BVY 13-023

SUBJECT: License Amendment Request; Changes to 10 CFR 50.63 Licensing Basis, Supplement 2
Vermont Yankee Nuclear Power Station
Docket No. 50-271
License No. DPR-28

Response to Request for Additional Information

Figure 1 - Temporary Fuel Oil Fill Connection

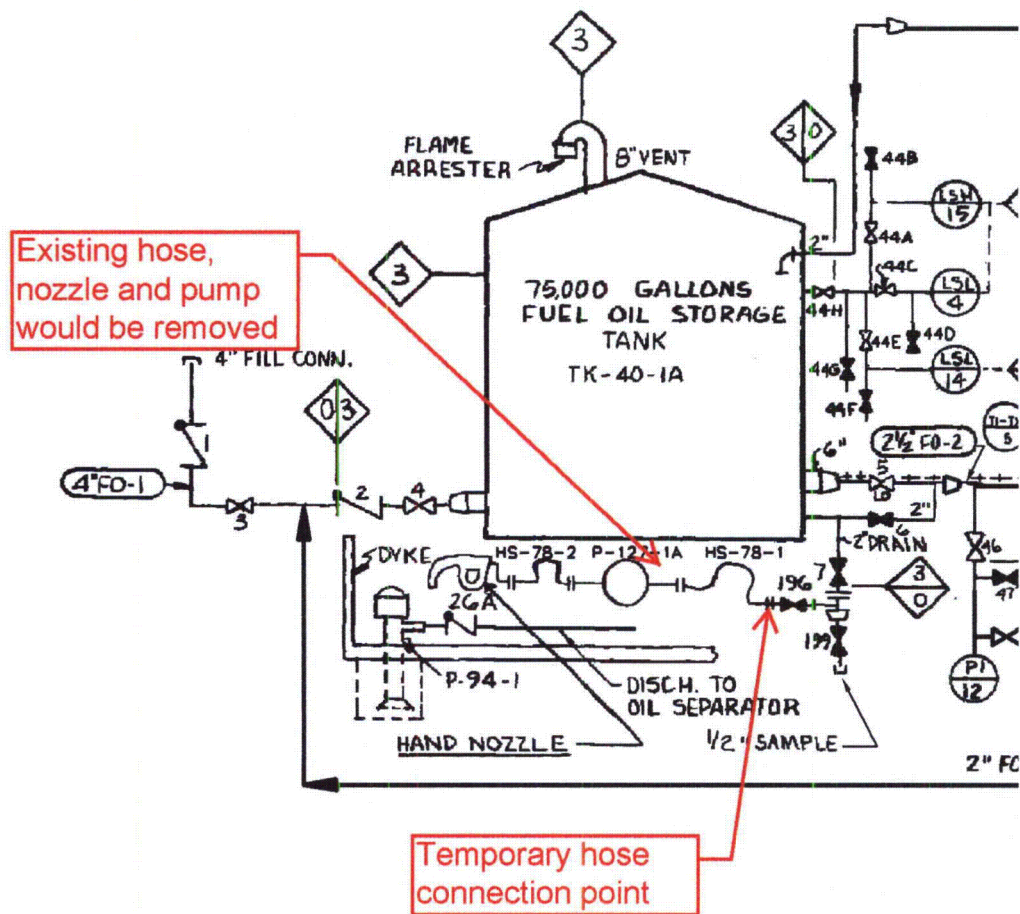
If a portable tank is used, describe how fuel oil is transferred from the emergency diesel generator (EDG) fuel oil storage tank to the portable tank and from the portable tank to the SBO DG fuel oil storage tank. If pumps are required, describe how they are powered. If a temporary connection between the storage tanks is used, provide a piping schematic showing where the connection is located in the existing fuel oil piping.

As documented in our license amendment request, the SBO DG will include a dedicated fuel oil storage tank with a capacity sufficient for operation of the DG at 100% rated load for at least 36 hours, which provides significant margin over the 8 hours of operation required by the coping analysis. This dedicated fuel oil storage tank will be separate from the fuel oil supply for the onsite emergency AC power system. As referred to in this question one possible means to refill the SBO diesel tank will be from the onsite EDG fuel oil storage tank using a portable tank or a temporary connection between these tanks.

Pump power can be supplied from new Bus 13 via the load center located in the SBO DG enclosure. Bus 13 is powered by the SBO DG; therefore, any electric-driven pump needed will remain powered during an SBO event. Other means may be possible including vendor-supplied deliveries, manual pumps or other vehicle battery powered pumps.

A piping schematic showing where the connection is located in the existing fuel oil piping is shown in Figure 1.
